**ITEM FOR ENVIRONMENTAL COMMISSION AGENDA**

COMMISSION MEETING DATE:	12/7/2022
NAME & NUMBER OF PROJECT:	Oltorf Site Plan (SP-2021-0091C)
NAME OF APPLICANT OR ORGANIZATION:	Oltorf Site Plan (Jim Wittliff)
LOCATION:	4544 E Oltorf, Austin, Texas 78741
COUNCIL DISTRICT:	3
ENVIRONMENTAL REVIEW STAFF:	Tunde Daramola, Environmental Review Specialist Senior, DSD, 512-974-6316, Babatunde.Daramola@austintexas.gov
WATERSHED:	Country Club West Watershed, Suburban, Desired Development Zone
REQUEST:	Variance request is as follows: Request to vary from LDC 25-8-301 to allow driveways on slopes over 15%. Request to vary from LDC 25-8-341 to allow cut over 4 feet up to 8 feet. Request to vary from LDC 25-8-342 to allow fill over 4 feet up to 20.5 feet.
STAFF RECOMMENDATION:	Staff recommends this variance, having determined the findings of fact to have been met.
STAFF CONDITIONS:	<ul style="list-style-type: none">• Provide 8 additional trees at 3 caliper inches.• Provide structural containment of fill with retaining walls.

Project Name: Oltorf Site Plan
Ordinance Standard: Watershed Protection Ordinance
Variance Request: **To allow driveways on slopes over 15% per LDC 25-8-301**

**Variance Requ

EXISTING SLOPE MAP

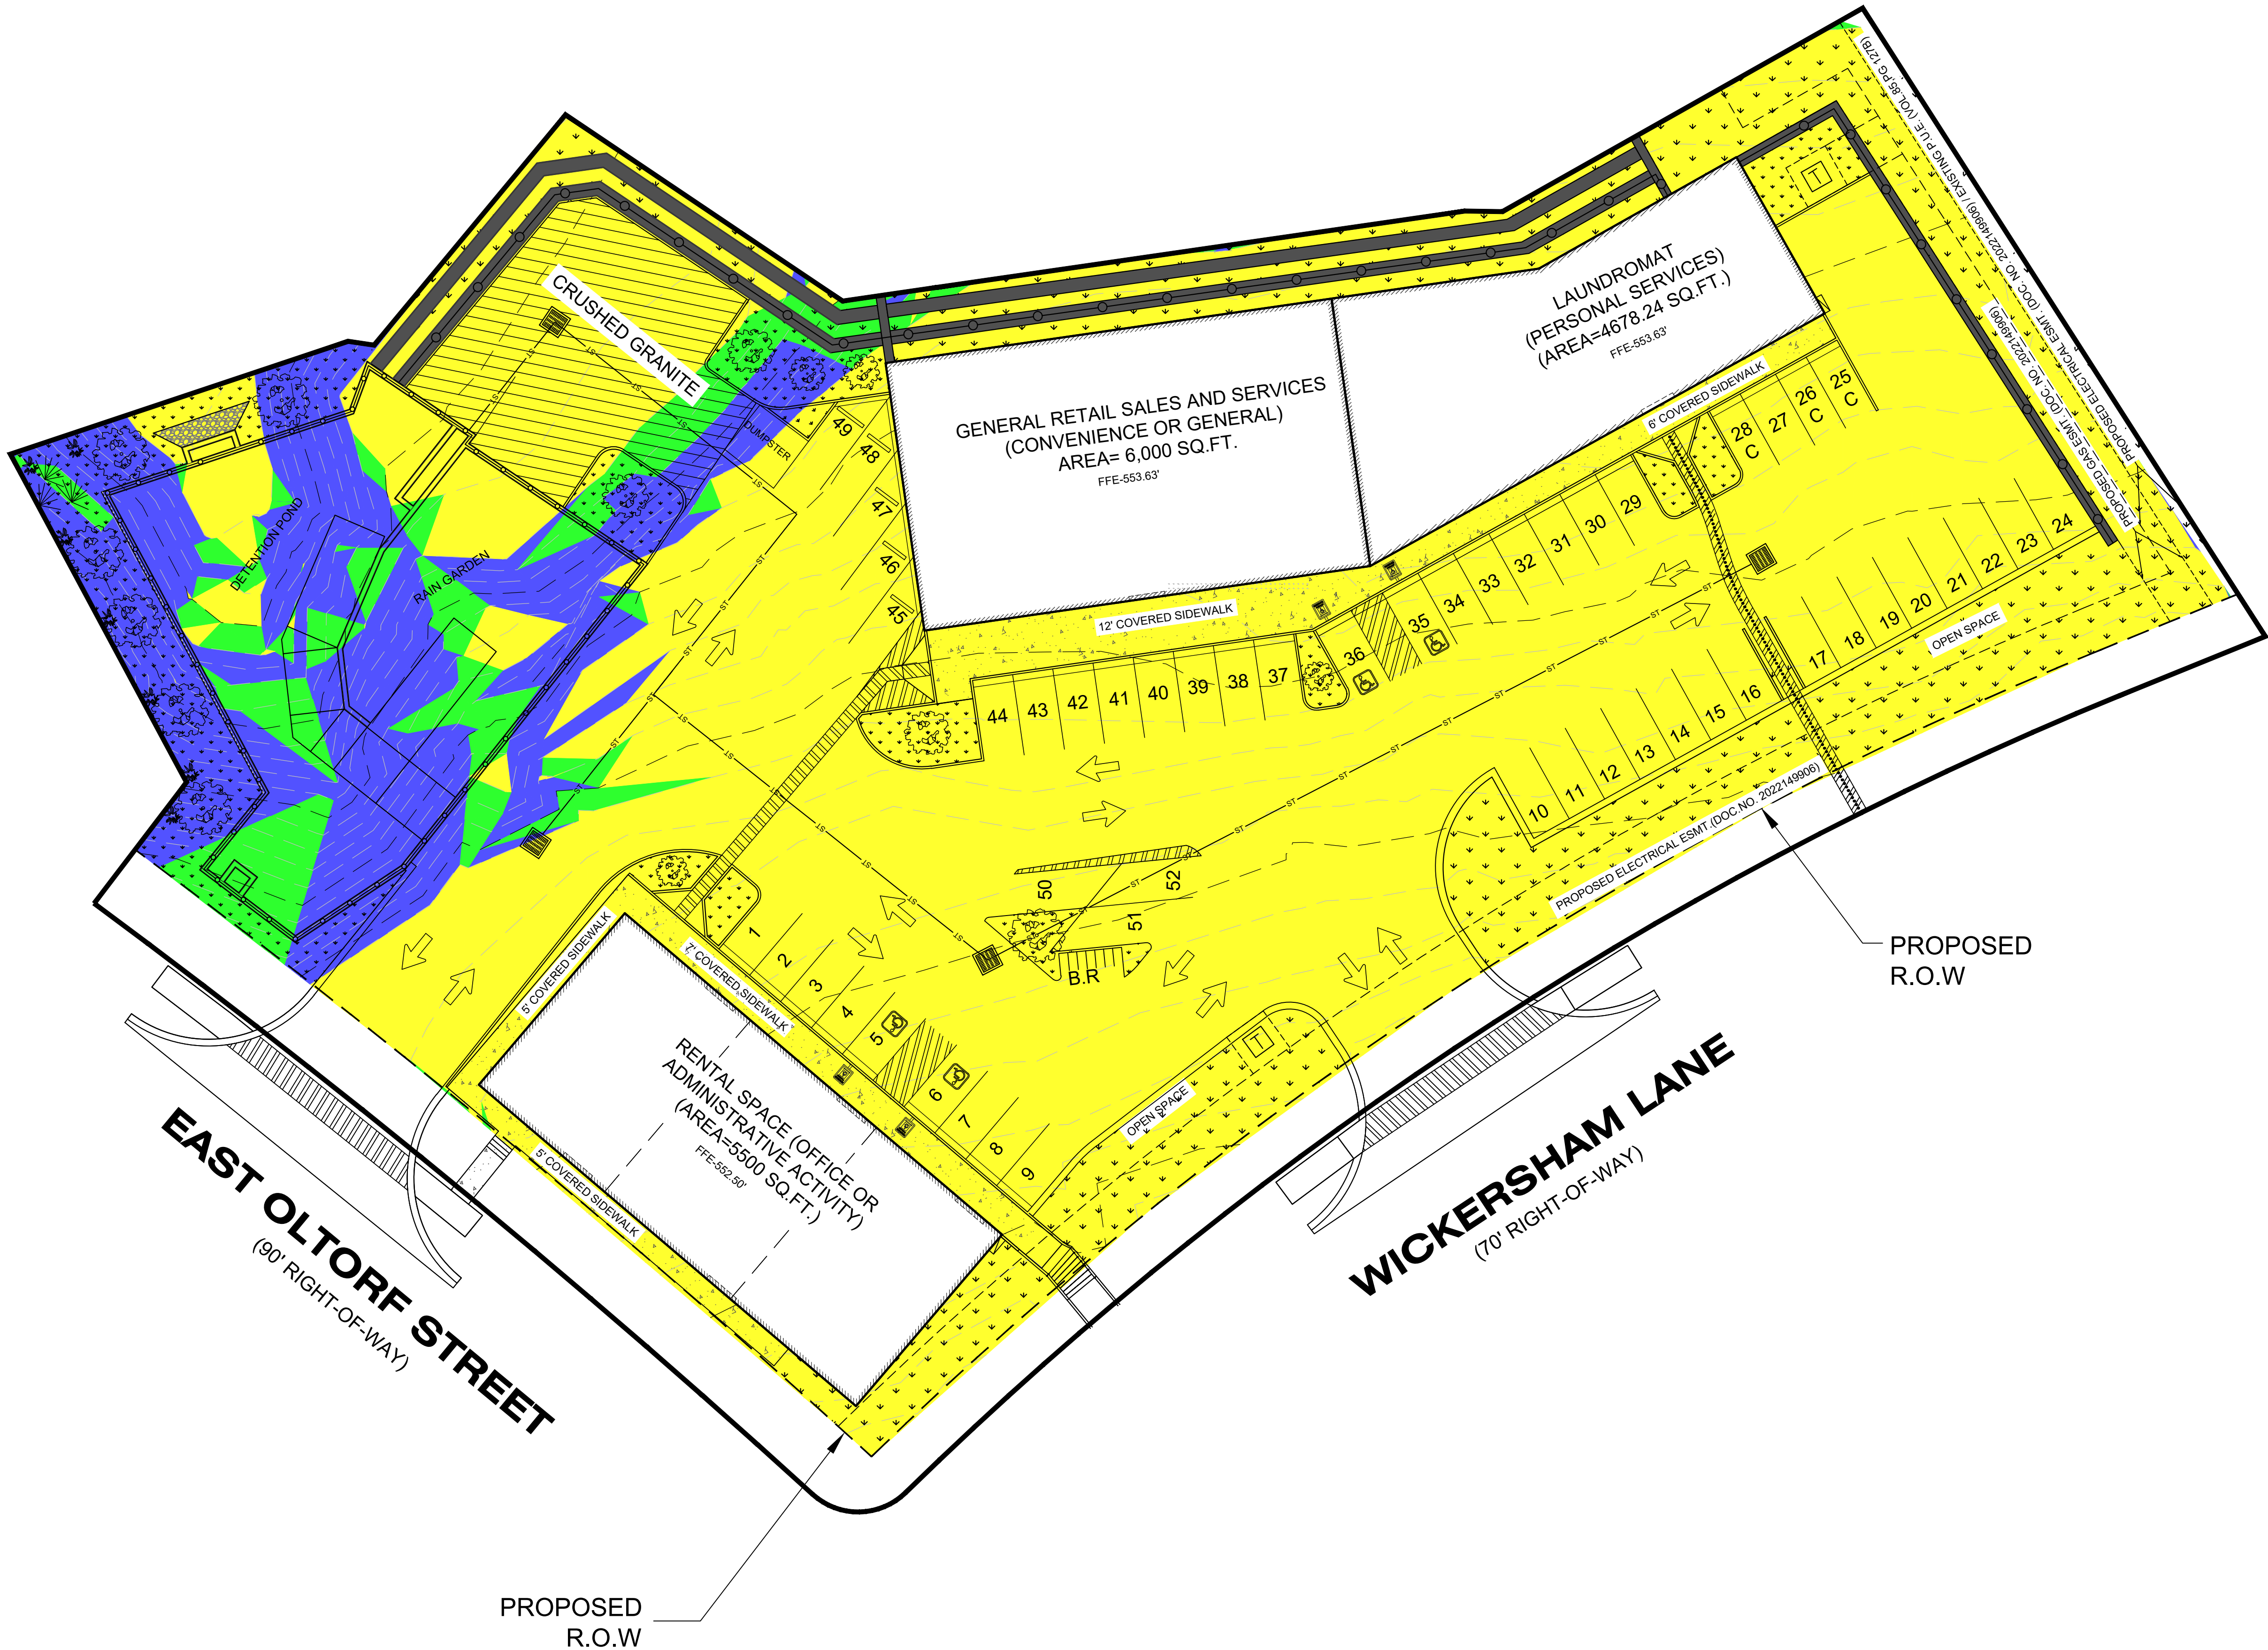
Yes. The variance will not be providing a special privilege to the applicant. The proposed buildings are similar in size to similarly situated property. Because the property is also subject to Austin's Commercial Design Standards Ordinance, 40% of the roadway frontage along East Oltorf is required to have building frontage adjacent to the right of way, therefore, the only available driveway access from Oltorf must cross existing slopes which are steeper than 15% gradient

Yes. Existing site conditions and accessibility regulations require the only available driveway access from Oltorf to cross existing slopes that exceed 15% gradient.

Clearly indicate in what way the proposed project does not comply with current Code (include maps and exhibits)	Cuts and fills will exceed 4 vertical feet. Driveway is proposed over existing slopes steeper than 15%
---	--

CUT/FILL EXHIBIT

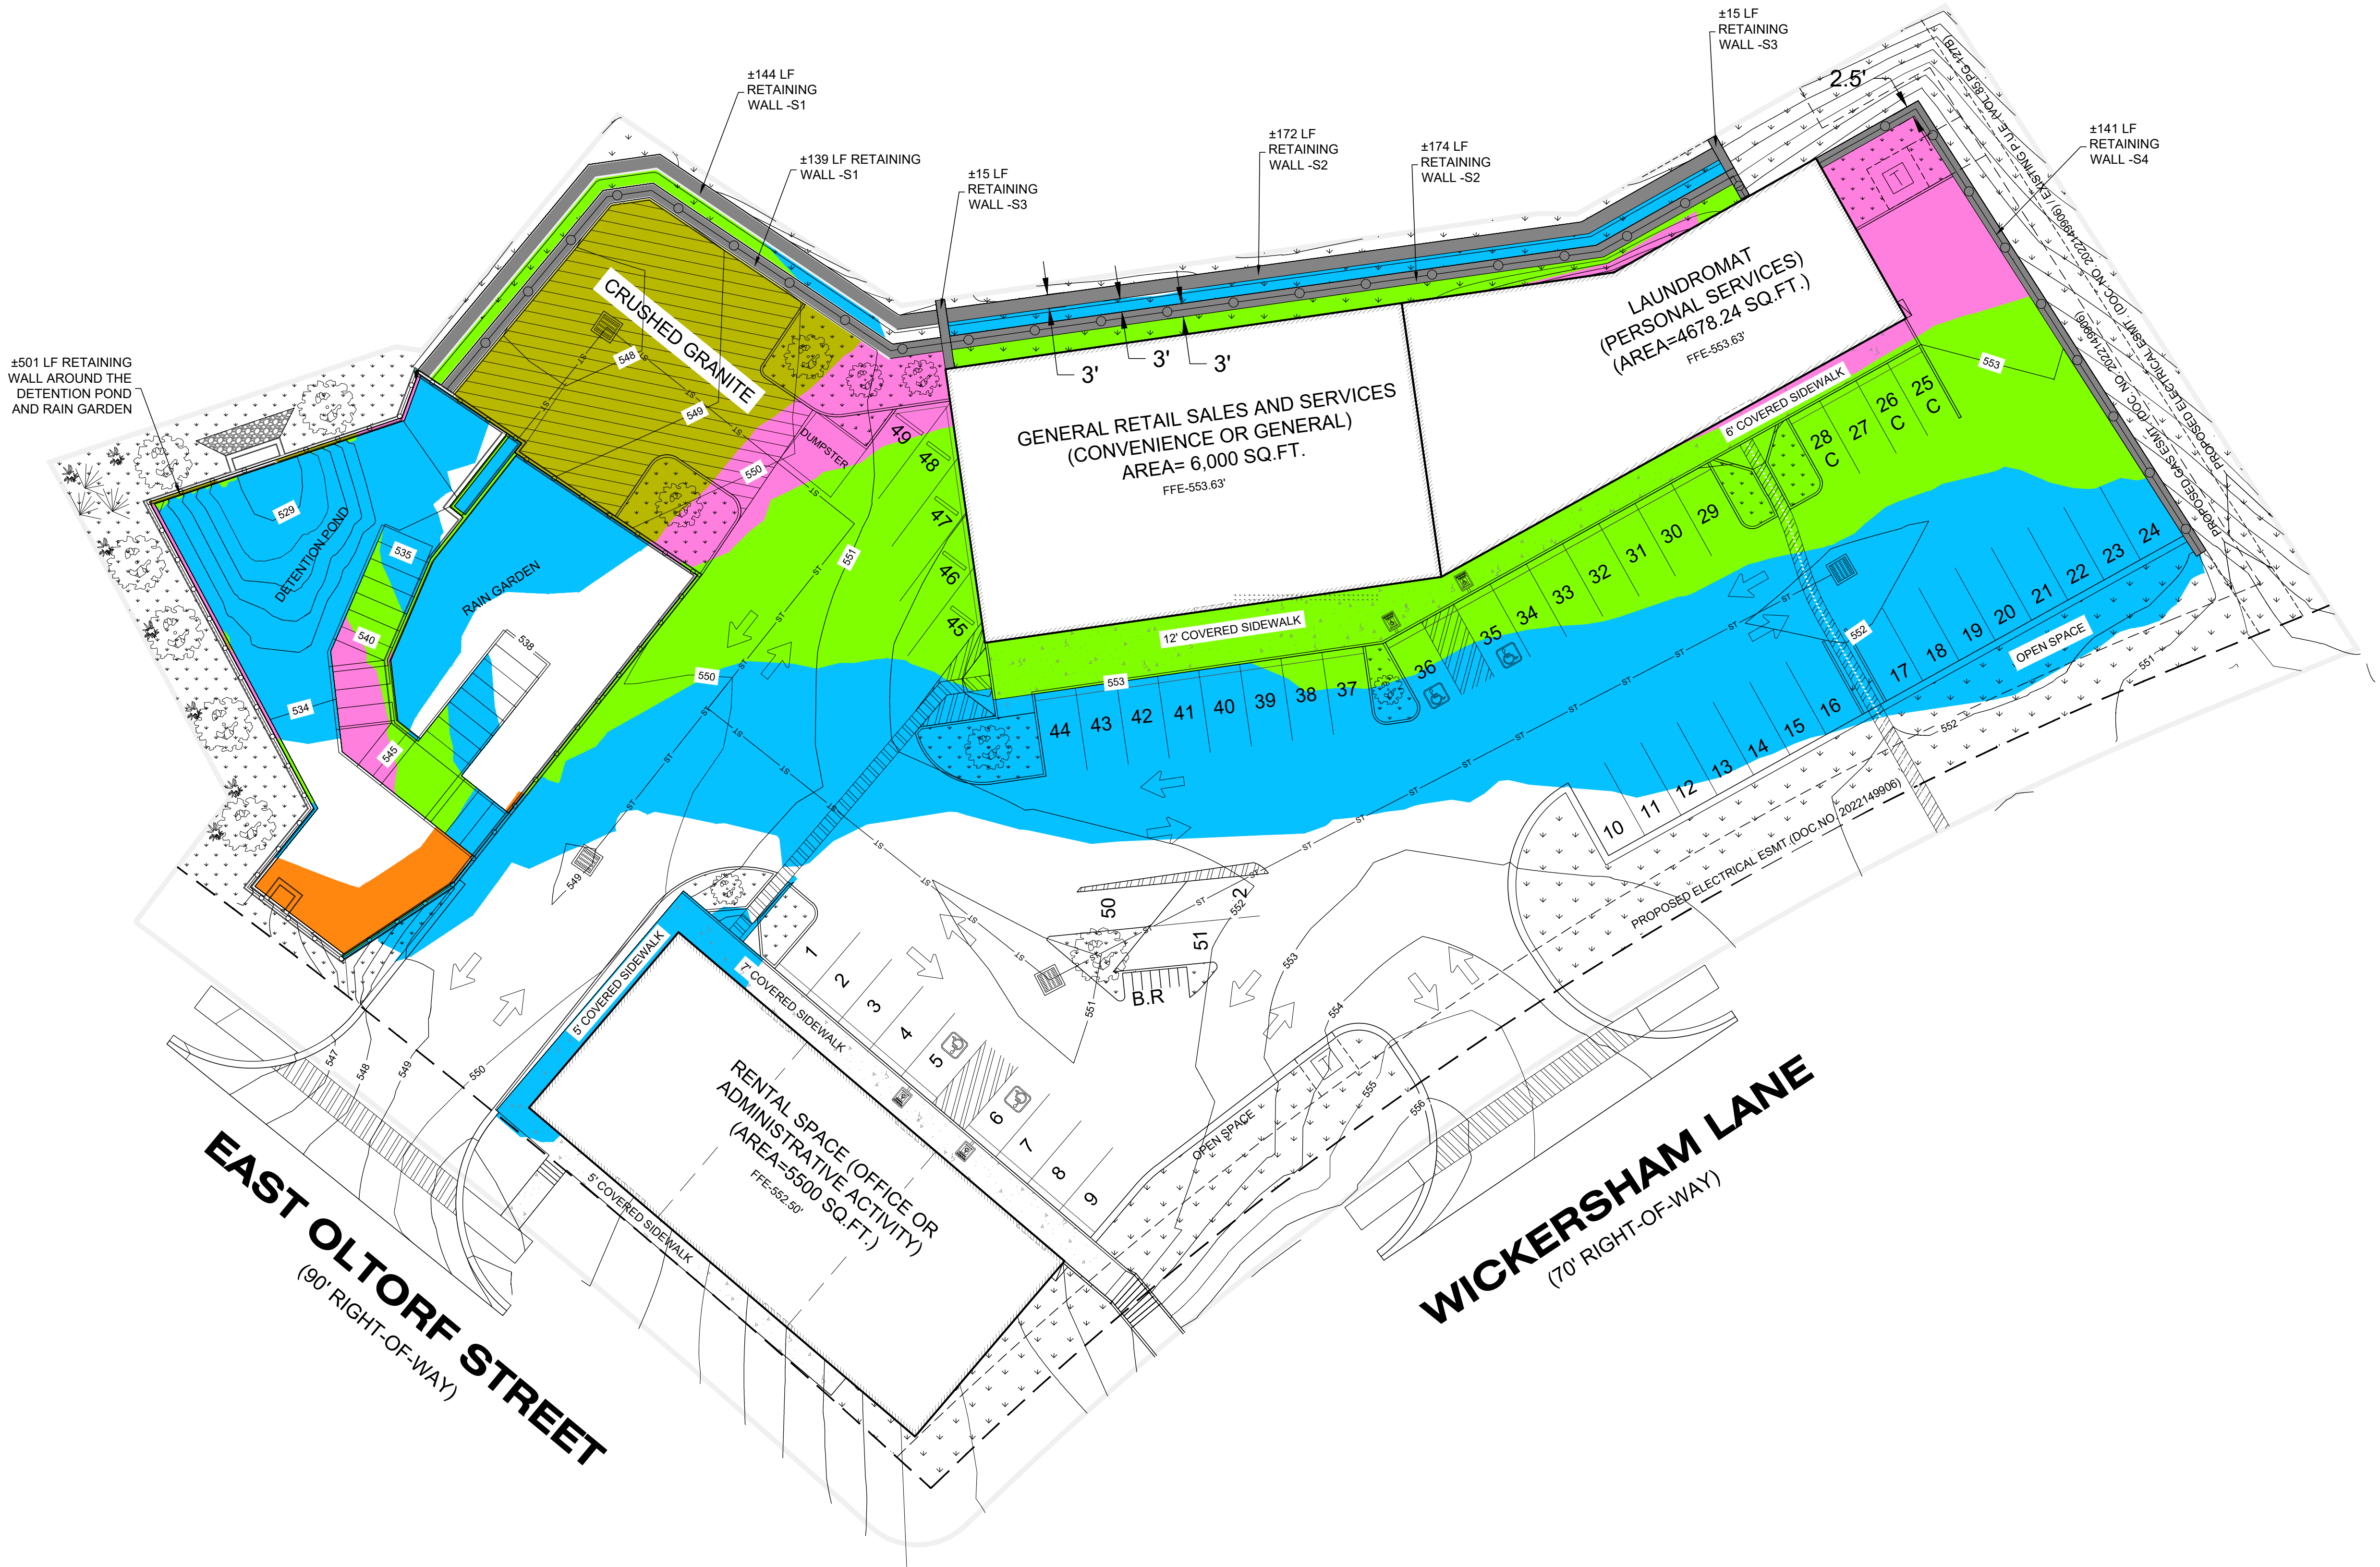
In order to facilitate this type of drainage which will require stormwater releases from detention ponds to flow into the storm sewer pipes along East Oltorf, grading within the detention/water quality area will have cut up to 8 feet and fill up to 20.5 feet.

Yes. The variance does not create a significant probability of harmful environmental consequences. The variance is a minimum deviation from code to allow for reasonable use of the property. Fill will be minimized and structurally contained with retaining walls.

outflows from the site; this requires us to grade approximately 435 square feet within the detention pond area of the site with cuts ranging between 4 and 8 feet, and to fill approximately 30,006 square feet of the site with depths of 4 to 12 feet, and to fill approximately 5,663 square feet of the site with fill to depths of 12 to 20.5 vertical feet. Significant redesigns were done in accordance with recommendations from Environmental staff, to eliminate vehicle parking spaces over original site slope gradients exceeding 15%, and to eliminate additional driveways on slopes over 15%.

- Provide 8 additional trees at 3 caliper inches.
- Provide structural containment of fill with retaining walls.
